Shore Gold Inc.

TECHNICAL MEMO

SUBJECT: Updated Water Management Strategy- Star-Orion South Diamond Project

CLIENT: 		
PROJECT: Star - Orion South Diamond Project		
Water Monitoring Sites- Revised		
DATE: March, 2013	ANALYST: AA	Figure 7.4-3
DWG NO: SKD373302	DWG: MY	
DWG FILE: DS-100-005_v4.mxd		PDF FILE: 09-100-005_v4_water_monitoring_sls.pdf
PROJECTION: UTM Zone 13	DATUM: NAD27

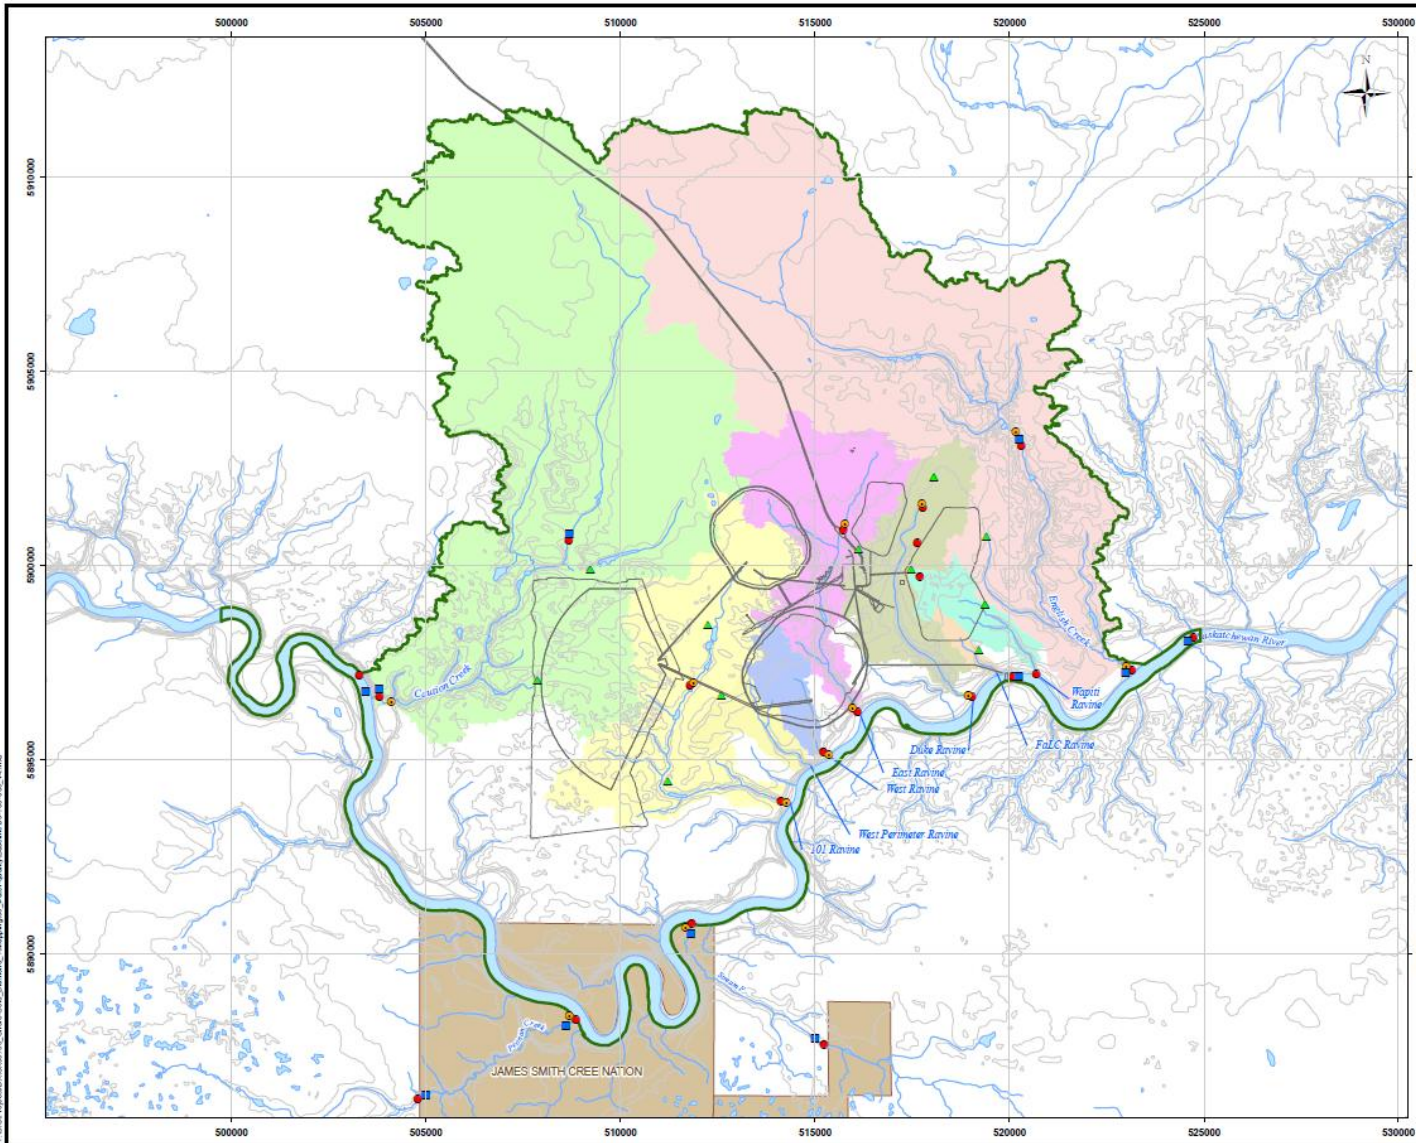
The water quality model (AMEC 2013) predicts water quality in site facilities (CPK Pile, PKCF) and in local watersheds based on mass balance calculations. As such, water quality monitoring sites have been selected as listed below. New sites added as a result of review comments are identified as well as sites previously listed in Table 7.4-1 of the revised EIS. Sites are presented on Figure 7.4-3 of the EIS that has been updated and included in this report.

Sites are presented on Figure 7.4-3 of the EIS that has been updated and included in this report.

Sites are presented on Figure 7.4-3 of the EIS that has been updated and included in this report.
